### TECHNICAL BULLETIN LTB00625NAS2 08 APR 2015

'Knock' Sound From Front Suspension

Range Rover Sport (LW)

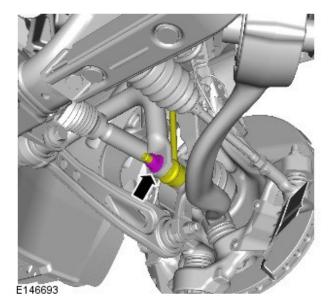
Front Suspension Knock Diagnostic Test (refer to step 1 of Diagnosis Procedure).

• If the noise is still present, continue to the next step.

Identification off vehicle:

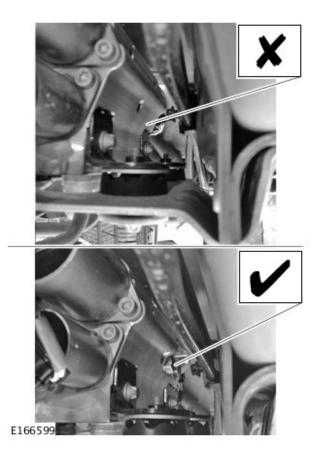
10. NOTE: On strong customer complaint please confirm which level of valve block is fitted. Valve block shown removed for clarity.

• If the vehicle is not fitted with the latest level (FPLA) valve block , install new valve block (see TOPIx Workshop Manual, Section 204-06) and then proceed to Step 14. If the vehicle is fitted with the latest level valve block then please proceed to Step 32.

If the vehicle is not fitted with the latest level (FPLA) valve block, install new valve block (see TOPIx Workshop Manual, section 204-06).

NOTE: Using SDD Carry out Dynamic response module - Valve block replacement to any vehicle being fitted with a new FPLA level valve block.
NOTE: Using SDD Carry out Hydraulic system test to All vehicles once valve block has been replaced.
